TECHNICAL SERVICE BULLETIN NSS[®] Enterprises, Inc.

Affected Products: All Charger 2717DB & 2022DB Models

Problem Description: The current system for adjusting pad pressure can be difficult to use.

Illustration:

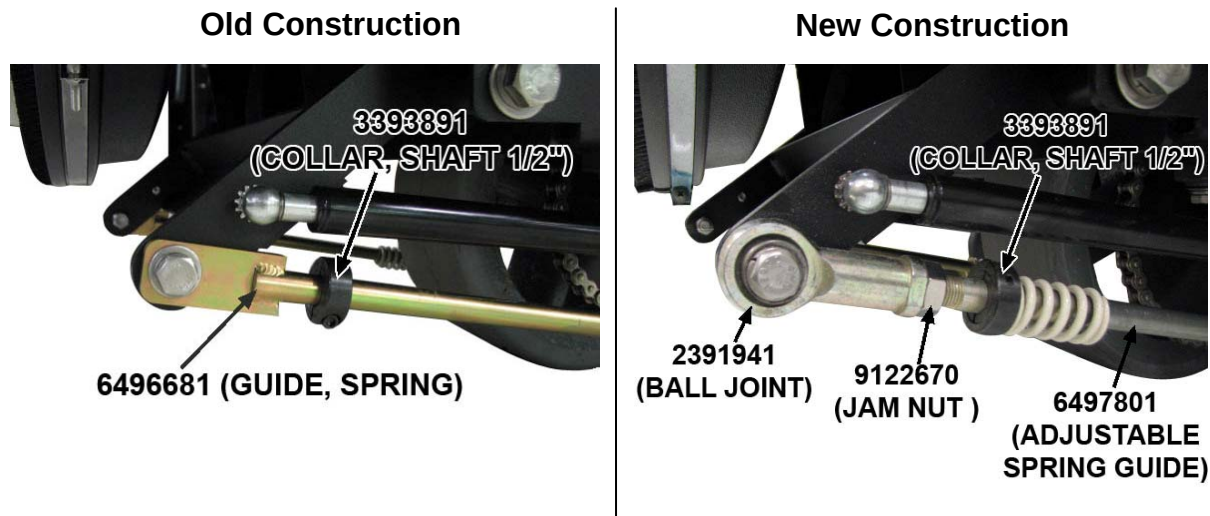
Corrective Action: The 6496681 (GUIDE, SPRING) was replaced with an adjustable spring guide, 6497801, and 2391941 (BALL JOINT). The new construction allows for fine adjustment of the pad pressure by loosening the jam nut and threading the spring guide either in or out of the ball joint to adjust the position of the locking collar.

Field Installation: This change is an improvement to the current design, but is not recommended for field installation unless the end-user needs to adjust the pad pressure frequently. Very few end-users should have this need.
